**RENAULT Twingo**

41 NEW POSITION OF BATTERY*Other sub-section concerned :***42****Basic manual : M.R. 306**

41 SPECIAL POINTS FOR VEHICLES EQUIPPED WITH AN AIRBAG**Basic manual : M.R. 306**

CONNECTION WITH SIDE MEMBER

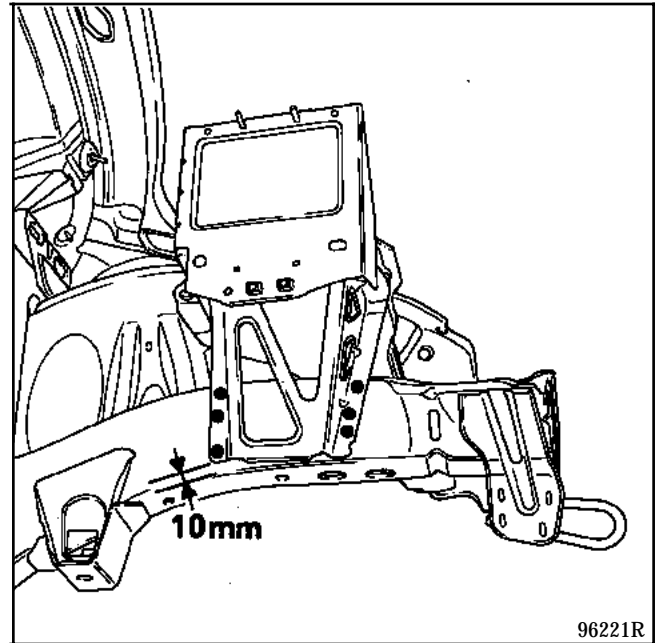
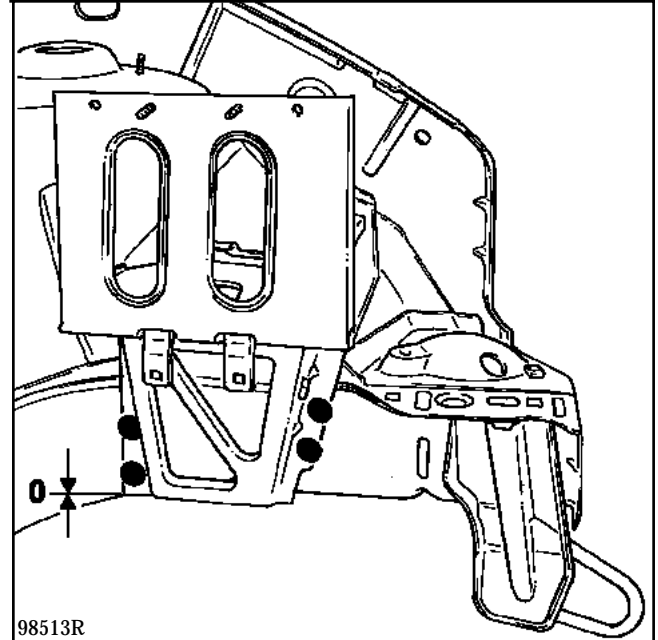
On these vehicles the battery has been turned through 90 degrees and lowered by 10 mm. This has resulted in the battery tray, bracket and wiring being modified .

Position on old vehicles.

Position on new vehicles.
